**Subject:** AP1000 COL Standard Technical Report Submittal of APP-GW-GLR-080 (TR 80)

Pursuant to 10 CFR 50.30(b), APP-GW-GLR-080, Revision 0, "Mark-up of AP1000 Design Control Document Chapter 7," Technical Report Number 80, is submitted as Enclosure 1 under the attached Oath of Affirmation.

1. APP-GW-GLR-080, Revision 0, "Mark-up of AP1000 Design Control Document Chapter 7,"  
Technical Report Number 80

Figure 7.1-1

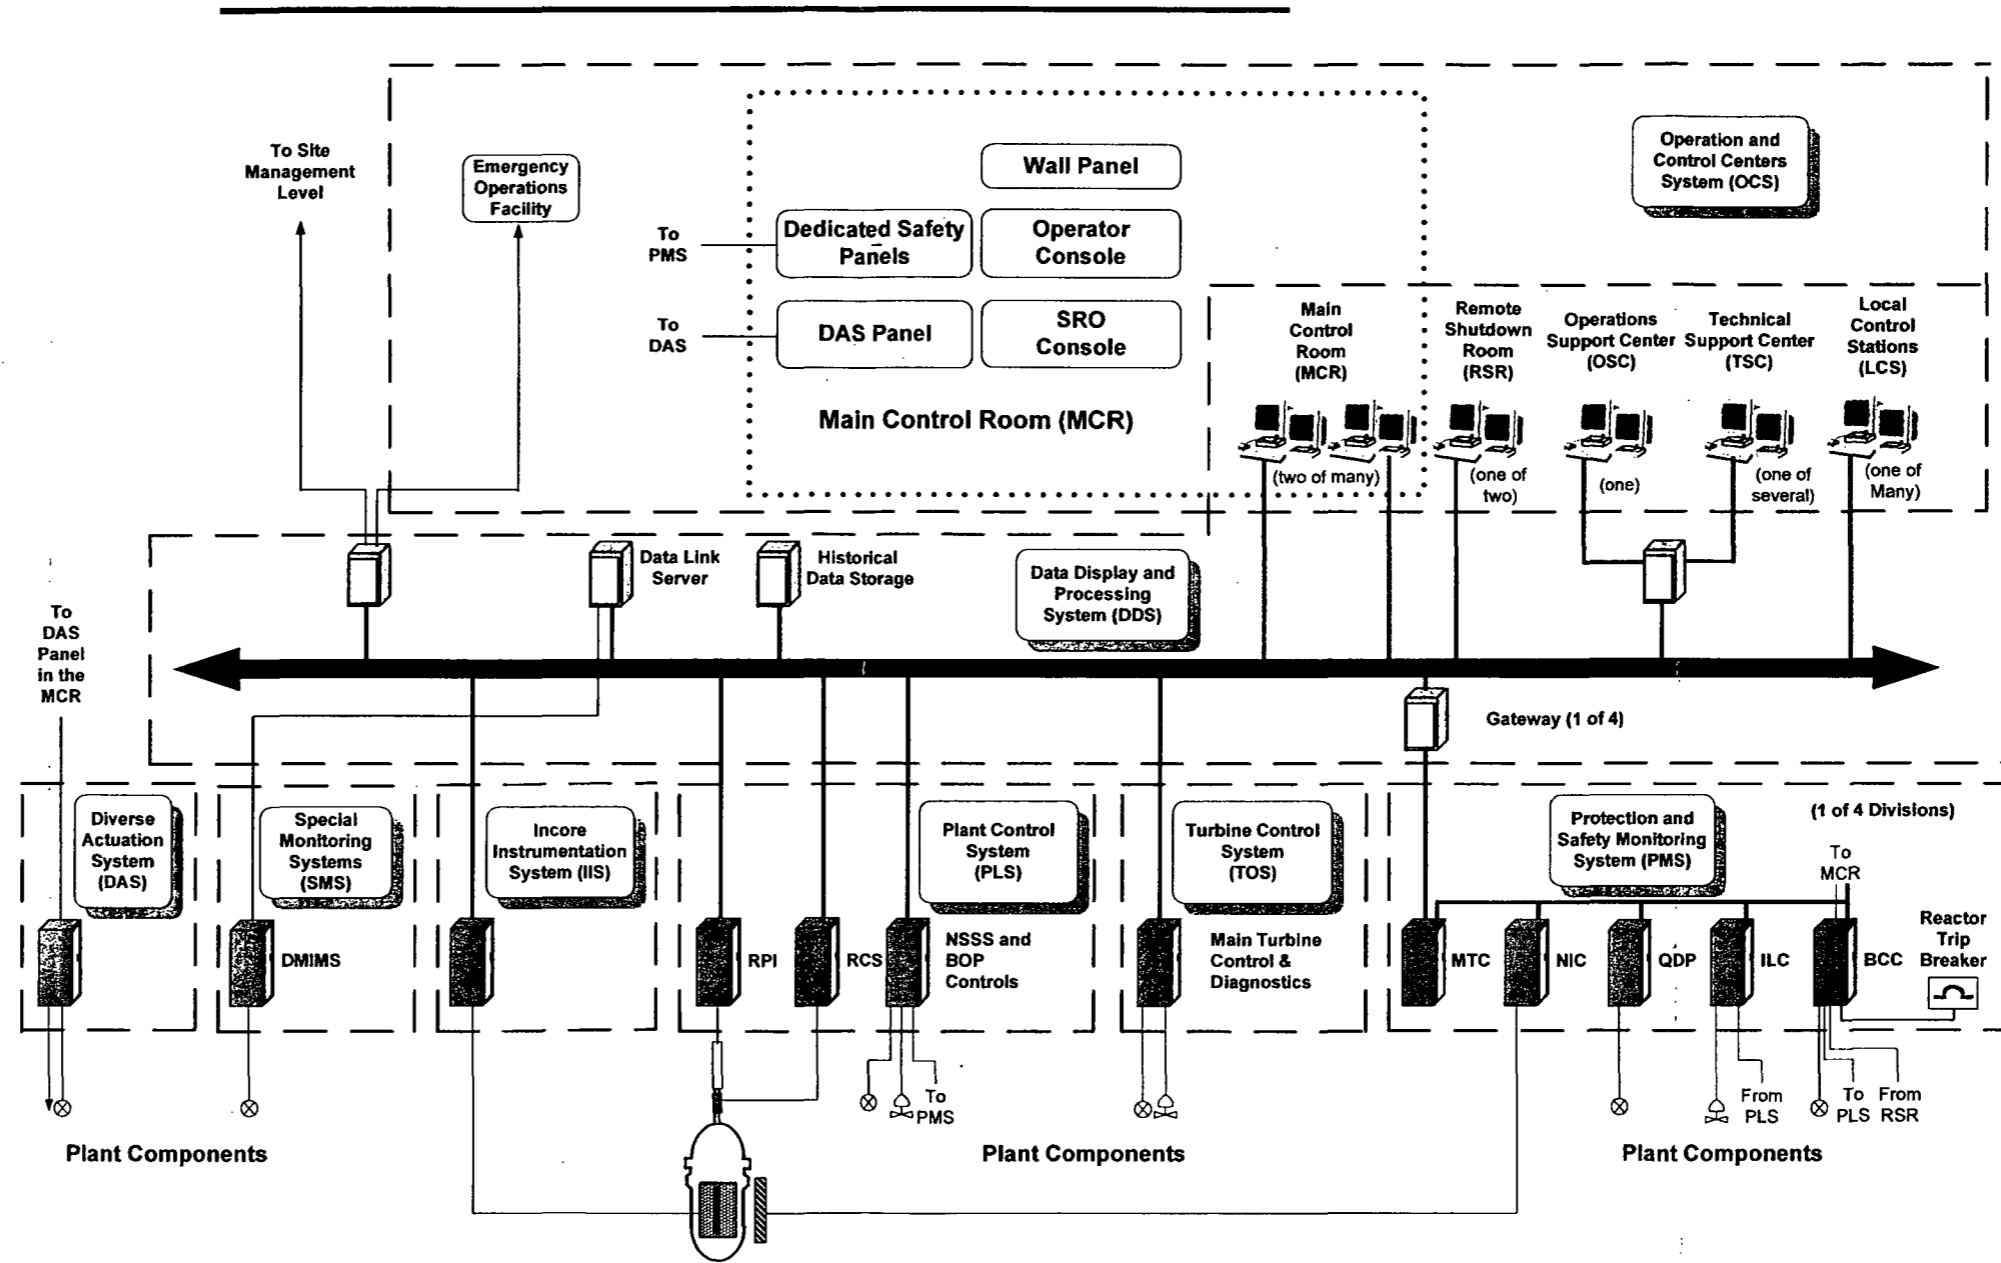
Figure 7.1-1 is revised to show the overall I&C Architecture consistent with the textual changes described elsewhere in this document. Figures 7.1-2 through 7.1-11 are deleted because the text that references them has been deleted or they are redundant to figure 7.1-1.

Figure 7.1-1 illustrates the instrumentation and control architecture for the AP1000. The figure shows two major sections separated by the real-time data network. Figure 7.1-1 depicts the real-time data highway as a single network. To meet cyber security concerns, the real-time data highway will be separated into security levels as described in Reference 22.

Figure 7.1-1, provides an illustration of the instrumentation and control architecture for the AP1000 and the plant control system.
